CLARIFICATION REGISTER: **TNPA/2025/05/0010/95183/RFP**: CONSTRUCTION OF THE MARINE WORKS FOR THE UPGRADE OF BREAKWATER (NEW DOLOSSES) PROJECT AT THE PORT OF RICHARDS BAY

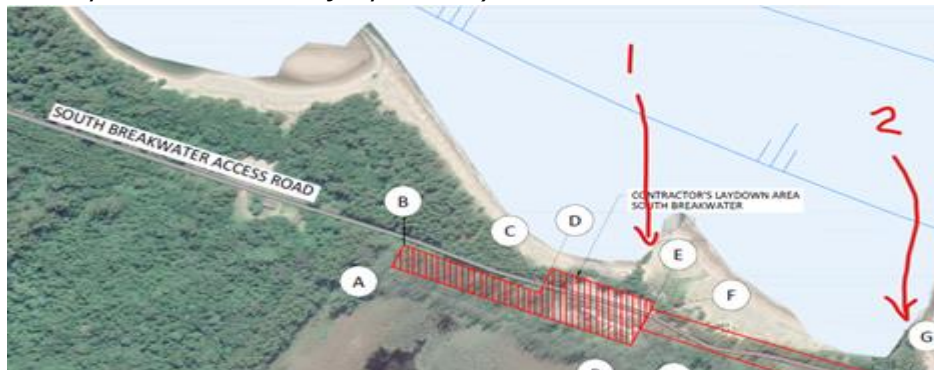
#	FROM	DATE RECEIVED	REFERENCE	CLARIFICATION REQUIRED/QUERY/REQUEST	TNPA RESPONSE																																																																																																												
1.	Stefanutti Stocks Coastal	13 – Nov – 25		Bill of Quantities item 3.4.1.1 refers. Please can you provide a drawing of the stainless steel handrailing.	<div></div> <div>4126515-1-001-S-SE-0002-01-02-TD.pdf</div>																																																																																																												
2.	M&D Construction Group	16- Nov- 25		Will you please provide a longitudinal section of the southern breakwater.	Section F (in South Breakwater Plan and Sections Drawing) shows a long section through the South Breakwater roundhead. A long section for the remaining 1km landward of the would simply show the concrete capping, layer works and core (as indicated in South Breakwater Demolition of Capping Drawing). Please may you request that M&D clarify what details they are looking for in a long section that are not currently shown in the drawing pack, and we can provide these.																																																																																																												
3.		16- Nov- 25		In the document it mentions that the contractor should provide a temporary jetty on the southern breakwater for personnel access, but it does not mention the exact position of the jetty. Please provide us a drawing indicating the position.	<p>We envisage the most practical position for the jetty is in the lee of one of the groynes below, close to the contractors South Breakwater laydown area. This image is from the general arrangement drawing. The exact position can be finalised by the contractor on site. (TNPA to confirm if this is correct or if there are any constraints on the jetty location)</p> <div>

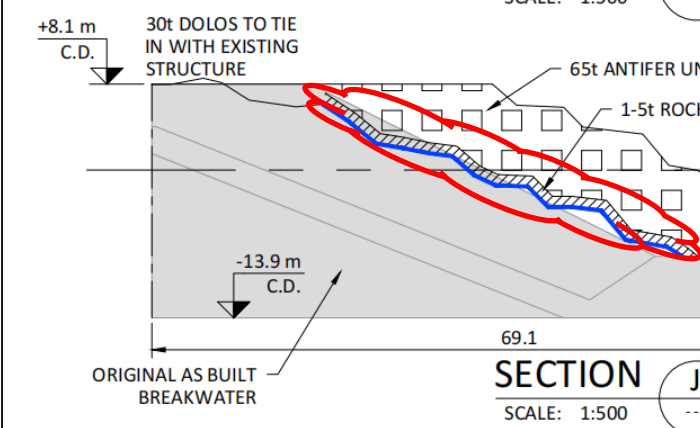
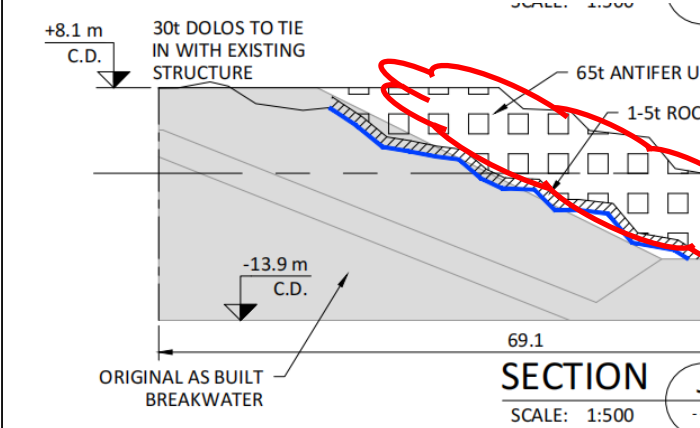
</div>	SITE BOUNDARY CO-ORDINATES			M			LOCATION	X	Y	LOCATION	X	Y	A	+3 188 516	-105 349	Q	+3 187 513	-106 796	B	+3 188 489	-105 362	R	+3 187 465	-106 847	C	+3 188 550	-105 502	S	+3 187 501	-106 885	D	+3 188 518	-105 515	T	+3 187 550	-106 833	E	+3 188 562	-105 623	U	+3 187 570	-106 832	F	+3 188 570	-105 619	V	+3 187 668	-106 924	G	+3 188 664	-105 882	W	+3 187 665	-106 939	H	+3 188 667	-105 934	X	+3 187 980	-107 316	I	+3 188 942	-106 676	Y	+3 188 079	-107 211	J	+3 188 944	-106 892	Z	+3 187 720	-106 916	K	+3 188 801	-107 189	AA	+3 187 706	-106 918	L	+3 188 927	-107 293	AB	+3 187 578	-106 806	M	+3 189 011	-107 024	AC	+3 187 588	-106 737	N	+3 189 029	-106 739	AD	+3 187 575	-106 736	O	+3 188 595	-105 608	AE	+3 187 545	-106 769	P	+3 188 616	-105 598			
SITE BOUNDARY CO-ORDINATES			M																																																																																																														
LOCATION	X	Y	LOCATION	X	Y																																																																																																												
A	+3 188 516	-105 349	Q	+3 187 513	-106 796																																																																																																												
B	+3 188 489	-105 362	R	+3 187 465	-106 847																																																																																																												
C	+3 188 550	-105 502	S	+3 187 501	-106 885																																																																																																												
D	+3 188 518	-105 515	T	+3 187 550	-106 833																																																																																																												
E	+3 188 562	-105 623	U	+3 187 570	-106 832																																																																																																												
F	+3 188 570	-105 619	V	+3 187 668	-106 924																																																																																																												
G	+3 188 664	-105 882	W	+3 187 665	-106 939																																																																																																												
H	+3 188 667	-105 934	X	+3 187 980	-107 316																																																																																																												
I	+3 188 942	-106 676	Y	+3 188 079	-107 211																																																																																																												
J	+3 188 944	-106 892	Z	+3 187 720	-106 916																																																																																																												
K	+3 188 801	-107 189	AA	+3 187 706	-106 918																																																																																																												
L	+3 188 927	-107 293	AB	+3 187 578	-106 806																																																																																																												
M	+3 189 011	-107 024	AC	+3 187 588	-106 737																																																																																																												
N	+3 189 029	-106 739	AD	+3 187 575	-106 736																																																																																																												
O	+3 188 595	-105 608	AE	+3 187 545	-106 769																																																																																																												
P	+3 188 616	-105 598																																																																																																															
4.		16- Nov- 25		The current closing date is 8 December 2025, with the site visit scheduled for 18 November 2025. This is a large-scale project with a 9CE CIDB grading, and it presents significant technical challenges due to the size of the elements, logistics, and environmental conditions, including weather and ocean factors. The tender also	Addendum No.1 to be issued extending the closing date to 30 January 2026.

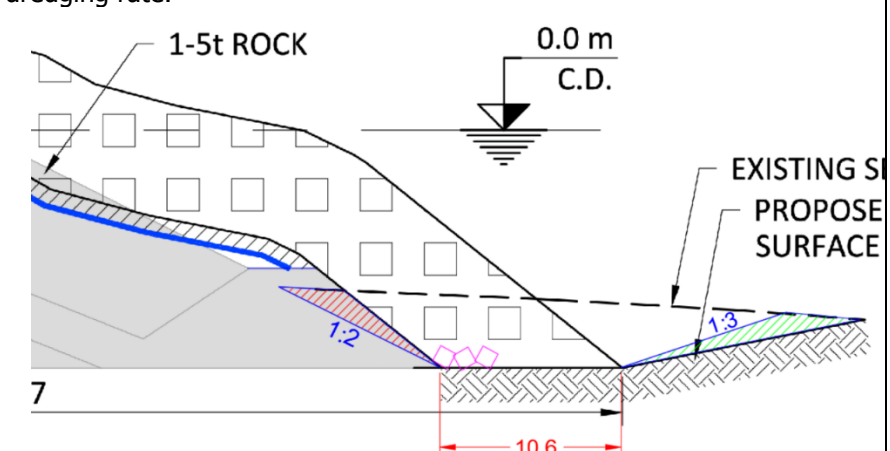
20.			<p>2025-07-17 IFC Drawings R1</p> <p>For the data "1~12m" circled in red on the general layout of does this data refer to the actual water depth or the current clarify.</p> 	<p>The circled area indicates -12.1m CD. All levels are relative to Chart Datum and based on the 2014 multibeam survey. Refer to drawing notes for clarification</p> <p>NOTES</p> <ol style="list-style-type: none"> 1. CO-ORDINATE SYSTEM BASED ON GAUSS CONFORM CLARKE 1880 LO31 2. ALL LEVELS ARE IN METRES AND RELATIVE TO CHART DATUM. 3. ALL DIMENSIONS ARE IN METRES. 4. ALL LEVELS AND DIMENSIONS ARE APPROXIMATE, TO BE REVISED FOLLOWING IN-SURVEY. 5. AS BUILT INFORMATION AND ARMOUR UNIT LOCATIONS ARE APPROXIMATE, AND BASED ON AVAILABLE INFORMATION. UNIT LOCATION AND QUANTITIES TO BE REVISED FOLLOWING IN-SURVEY. 6. MULTIBEAM SURVEY SOURCED FROM CSIR 2014.
